Front Suspension – Knocks – New “V” Mount Introduced

MODEL 1995 MY
Sedan RangeVIN
720001 - 722757**ISSUE:**

ILLUSTRATION 1

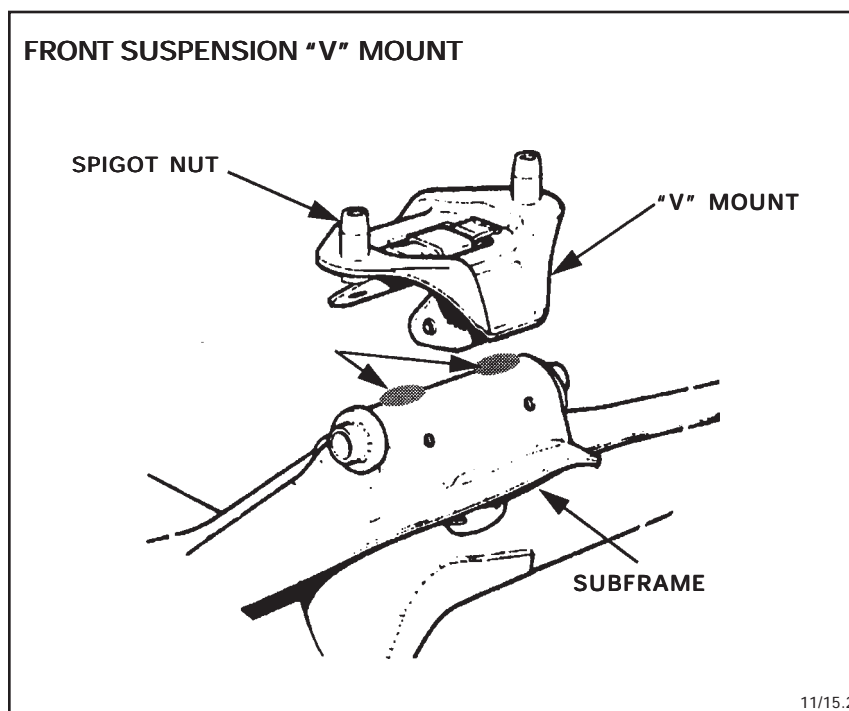
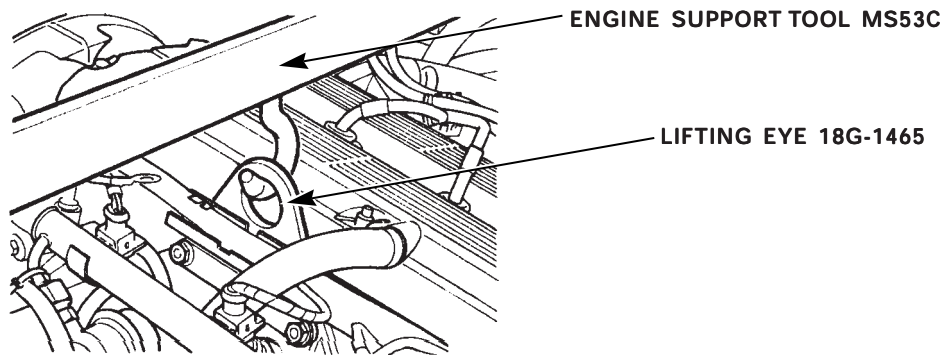
Knocks or rattles from the front suspension of 1995 MY Sedan Range vehicles within the above VIN range may be caused by the front suspension “V” mount spigot nuts contacting the front subframe (crossbeam). A new “V” mount with shorter spigot nuts was introduced in production at VIN 722758.

If a customer complains of a hard knock from the front suspension of a 1995 MY Sedan Range vehicle within the above VIN range when driving over a rough road surface, check for evidence of contact between the front suspension “V” mount spigot nuts and the front suspension subframe (Illustration 1). If contact is found, replace the existing front suspension “V” mounts with new “V” mounts (part number MNA 2360AD) as follows:

16. Remove the "V" mounts from the subframe.
17. Install the new "V" mounts on the subframe. Torque the bolts to 11.4 lb. ft. \pm 2.6 lb. ft. (15.5 Nm \pm 3.5 Nm).

ILLUSTRATION 5

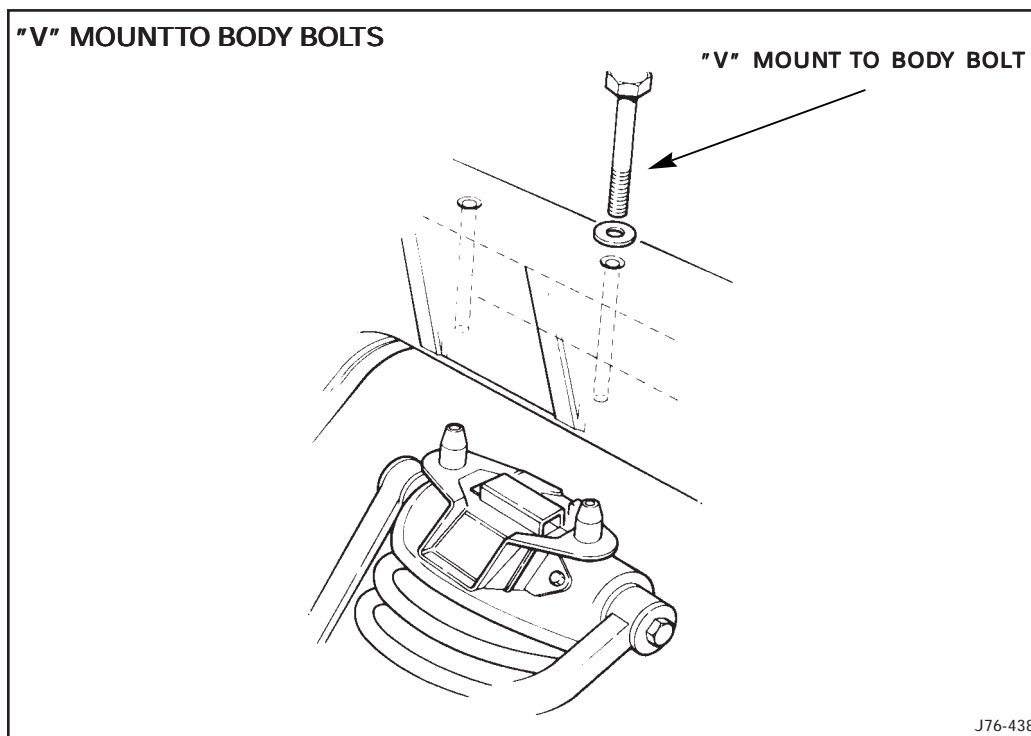
14. Remove the "V" mount bolts from inside the engine compartment.
15. Carefully lower the suspension subframe enough for the "V" mounts to clear the body (Illustration 5).
